**Colusa Unified School District**  
**COLUSA HIGH SCHOOL AG BARN SITE UTILITIES**  
**Bid Package #16-100**  
**ADDENDUM NO. 1**

March 4, 2016

# COLUSA HIGH SCHOOL AG BARN SITE UTILITIES

### ADDENDUM NO. 1

## SEWER CONNECTION

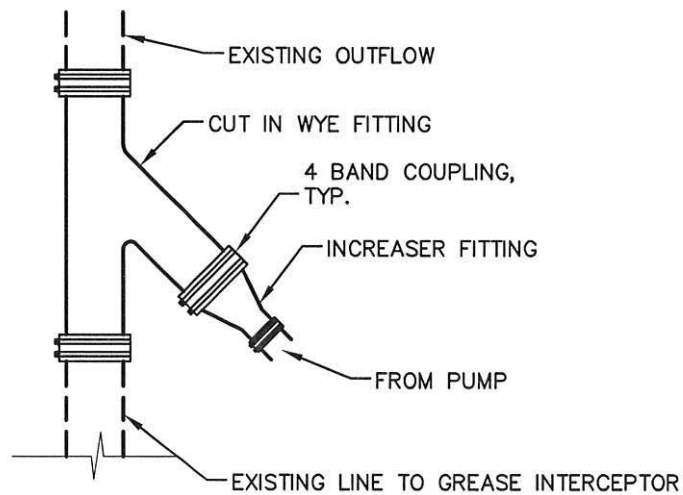
**1.20** Drawing C1.1, Utility Plan notes: add attached detail 4/C1.1 to note 21. Sewer connection.
